A STUDY IN TEAK

DOORS — MADE IN VENEER

Same design · Planted mouldings · Construction only

| REV<br>2 — the design unchanged; only the construction differs | DWG<br>AST-DR-015  |

THE SAME DRAWING AS THE DOOR SHEETS — NOT A REDRAW

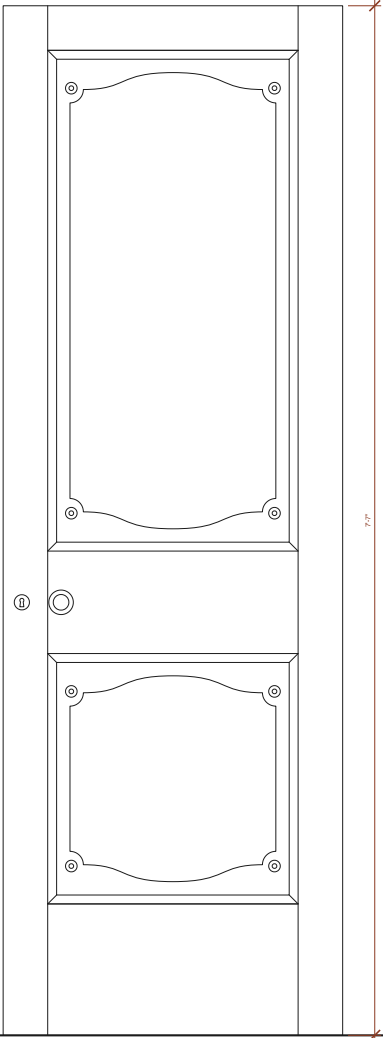
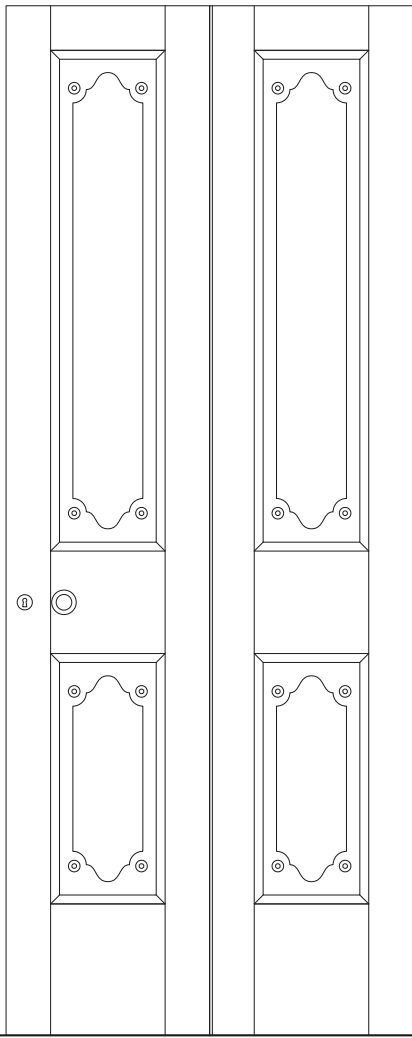
Both elevations are generated from the door sheets' own code, so the design cannot drift. Nothing on this sheet changes how the door LOOKS — only how it is made.

The design is not up for change here. If the shaped bead or the roundels ever change they change on AST-DR-001 and -009, and this sheet follows — it draws from the same code.

SECTION ACROSS A PANEL · 1:2 · EVERY MEMBER PLANTED ON

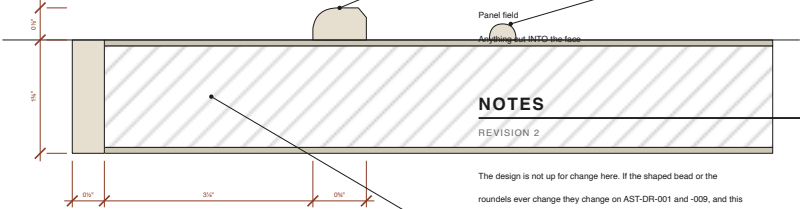
THE SAME MEMBERS, MADE SEPARATELY AND GLUED ON

was: sunk 13.5 into the solid  
now: stays FLAT — the ovolo round it does the work  
**Ovolo sticking**  
was: worked on the stile edge  
now: run as a separate 20 x 12 moulding, mitred on  
**Shaped bead**  
was: carved into the panel face  
now: bandsawn to the curve in 10 x 6, planted on  
**Corner roundels**  
was: carved bosses  
now: turned discs Ø26 x 5, glued on  
**The leaf**  
was: solid teak, 45  
now: 38 blockboard, 12 lipping, veneer both sides

**BLOCKBOARD CORE**  
Lipping is solid teak on all four edges so the leaf can be trimmed on site and the hinges and lock screw into wood, not into board.

Veneer both faces of the core and balance it: same thickness back and front, or the leaf will bow.

Ovolo, bead and bosses in solid teak, polished to match. They are small enough to take solid without moving, and they give a crisper artis than a cut face would.

Set the bead out from the panel opening, not from the leaf edge, so the four roundels land exactly on the corners of the curve.

**OPEN** — glue and pin, or glue only? Pins need filling and the filler shows through polish. Glue and cramp if the shop can.
